Re: Response to Federal Airways & Airspace's Letter, dated August 6, 2026, Regarding Special General Land Use Plan Study at 1401 Langston Boulevard, Arlington, VA

Subject: Potomac Overlook – 1401 Langston Boulevard Special General Land Use Plan (GLUP) Study

Exhibit 1: Critical Air Navigation Surfaces

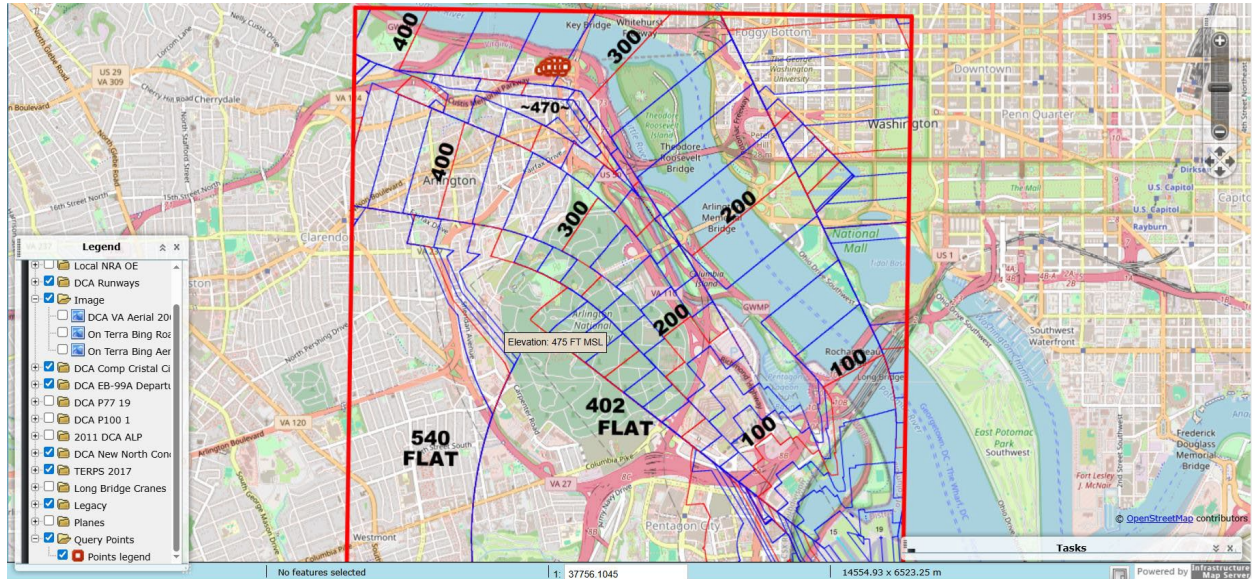
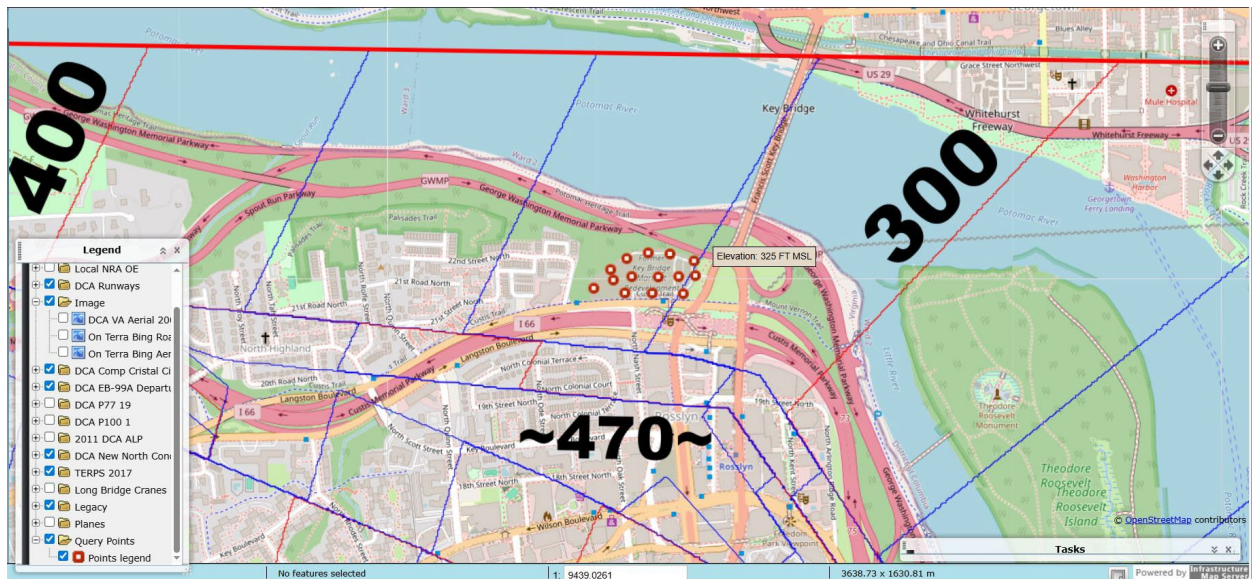
Due to the proximity to the Airport, there are Critical Air Navigation Surfaces that should not be impacted by the buildings, structures, or appurtenances. If these surfaces are impacted, there will be an adverse impact to Airport operations. Exhibit 1 below shows the impacted critical air navigation surface. Given the limited information available, fourteen evaluation points around the proposed development site were selected. Exhibit 2 shows the allowable structure heights at these evaluation points. The proposed maximum building height has been analyzed and the maximum structure height allowable without adversely impacting Airport operations ranges approximately between 325’ AMSL and 338’ AMSL, which means no structure at the proposed site should exceed these heights. Structures higher than this may have an adverse impact on the one-engine inoperable (OEI) surface.

Exhibit 2: Allowable Structure Heights

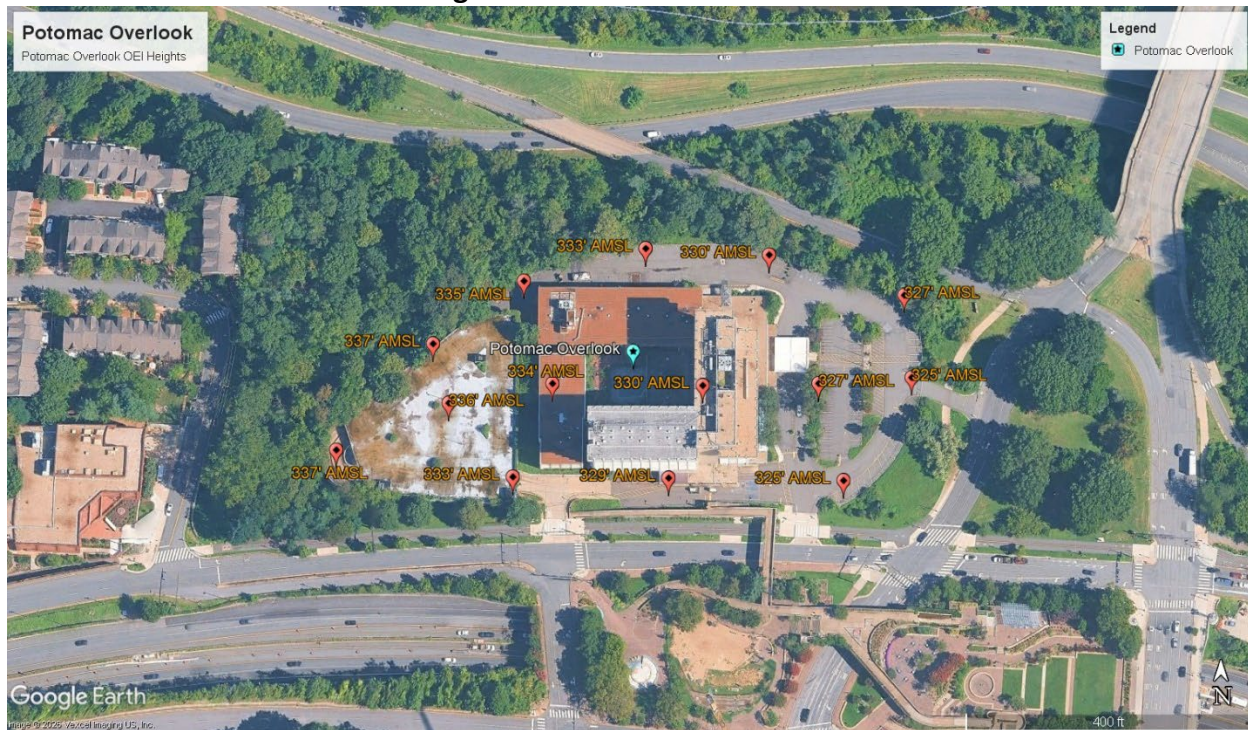
Construction cranes for the proposed development, which likely will be 30' – 40' above the top of building, will also have adverse impacts to Airport operations. A crane plan is required which identifies location, height, and time of service. Further discussion is required among Arlington County and the Airport as this plan is developed.

Exhibit 3: Arrivals/Departure Tracks

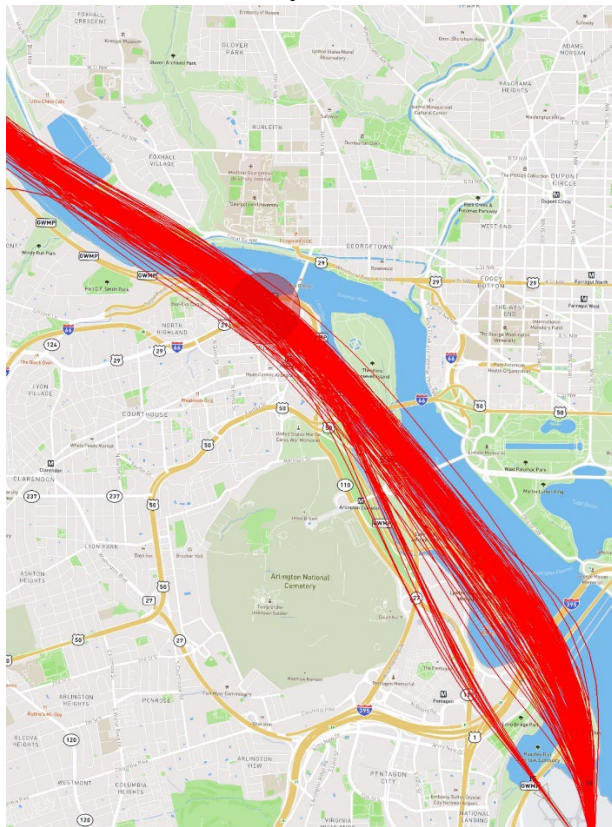
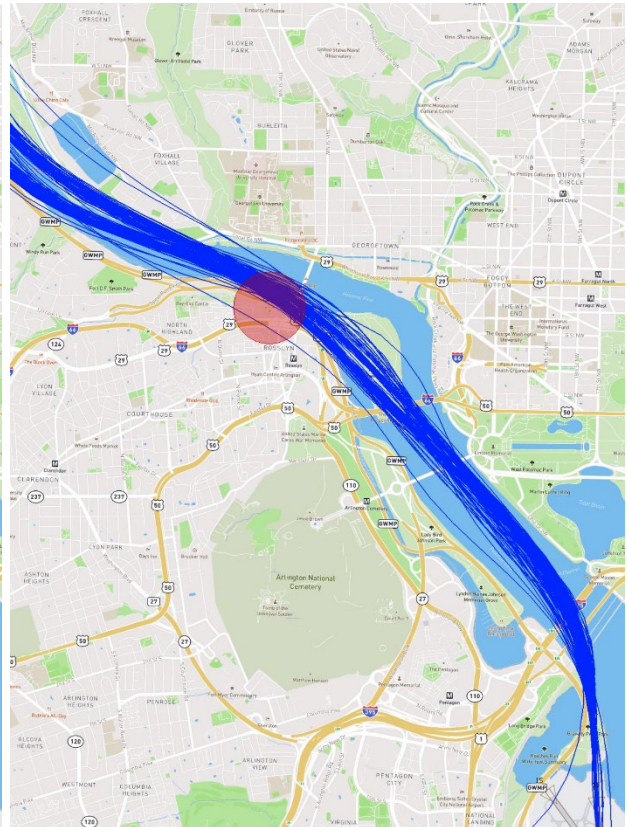
The proposed site will be exposed to loud and frequent noise from low-flying arriving and departing aircraft because of its proximity to DCA, and operations are projected to increase in the future. Large aircraft will fly overhead around the clock and at low altitudes. Resident complaints regarding these overflights and their noise could generate public and political opposition to airport activity, which would adversely impact airport operations and the airport's contribution to the local economy. For these reasons and consistent with the Airports Authority's prior comments and concerns about residential developments under flight paths

The flight track graphic show typical departure and arrival flight paths over the proposed parcels (see Exhibit 3). Note: on the graphic below, departures (red lines) will be between 2,500 and 3,000 feet in altitude (with jet engines generating to augment aircraft lift and the climb-out) and the arrivals (blue lines) will be at 1,000 feet above ground in altitude (with jet engines generating to ensure the aircraft is on the appropriate descent trajectory) over the river and abeam this location. The Airport Authority would also like to note that the proposed development should not shine light upward into the night sky which may impact flights overhead. Lastly, we understand the property will have an outdoor amenity where aircraft noise exposure likely cannot be mitigated.
